**Project: IEEE P802.15 Working Group for Wireless Personal Area Networks (WPANs)**

**Submission Title:** [802.15.3c comment resolution on #2, 7, 17, 19, 29, and 36]

**Re:** [In response to IEEE P802.15-08-0020-03-003c-df0-comments]

- D-ACK frame format in 802.15.3/3b

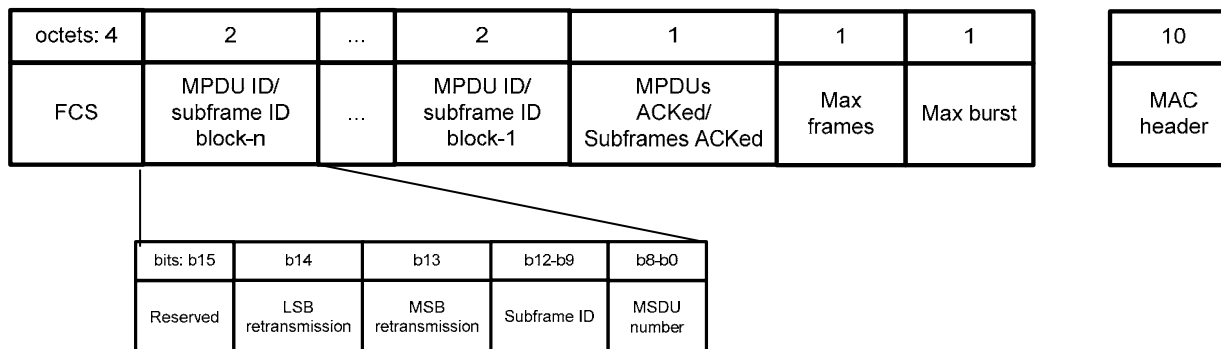
- Issue Number #7 : (1) Will Dly-ACK do what is necessary for Blk-ACK or (2) are there unique things that Blk-ACK needs to do. (3) Also, can this concept be extended to include the AV PHY directional ACK.
- Resolution :
  - (1) Conceptually, Yes,
    - But, Dly-ACK is based on MPDU indication while Blk-ACK is based on subframe indication.
    - Dly-ACK frame format needs to be changed to support aggregation
  - (2) Yes. MSB/LSB indication are included in Blk-ACK.
    - In order for Dly-ACK to keep current functionality of Blk-ACK, Dly-ACK should preserve MSB/LSB indication.
  - (3) Need more discussion.

- Blk-ACK is suggested to be eliminated from baseline document and use Dly-ACK with suggested changes

- Suggested change for D-ACK frame format

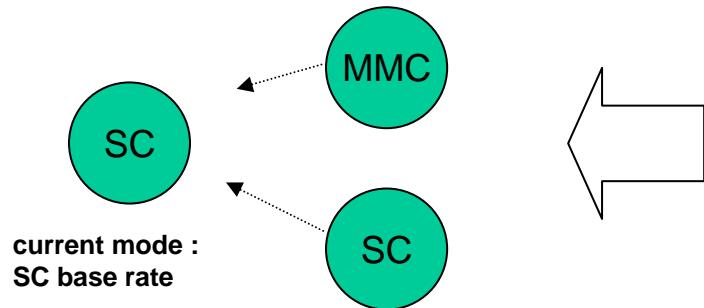
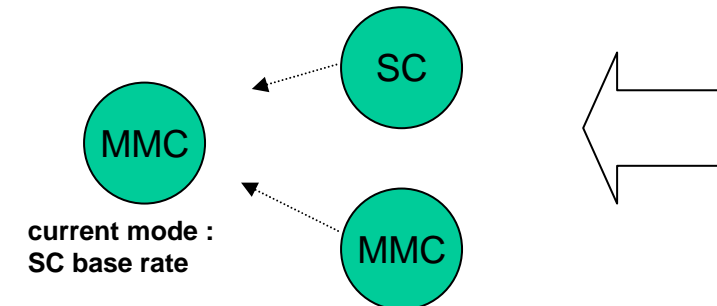
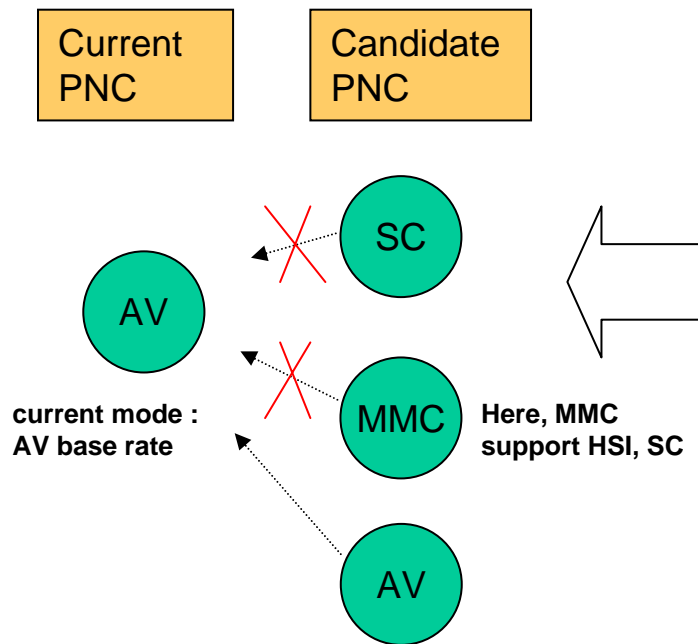
- Issue Number #19 : Need rules to describe that the beacon PHY mode shall not change while in operation. Also, that on handover, the new PNC uses the same PHY mode for the beacon as the old PNC. If so, we may be able to leave PNC Des-Mode as the top criteria for handover.
- Resolution : MMC (a PNC capable device supporting multiple PHYs) would be more desirable to be PNC since it supports SC base rate. But we need a restriction that device being handed over should maintain current transmission mode after handover. For example, current device is SC and candidate device is HSI/AV OFDM capable. After handover, it shall maintain SC base rate.

- Devices between different PHYs can not communicate with each other. Only way to communicate between devices thru either.
  - Same PHY
  - SC base rate

• MMC PNC (same transmission mode + multi-mode) is first priority and SC (same transmission mode) is second priority.

- Since AV PNC only support AV PHY, it can't talk with SC or MMC
- So SC/MMC can't be heard and can't be candidate PNC
- Only device supporting AV can be candidate.

- Suggest Priority order (on the table 55 in P802.15-3c-DF1)
  - 1. PNC desire mode
  - 2. Same transmission mode
  - 3. MMC
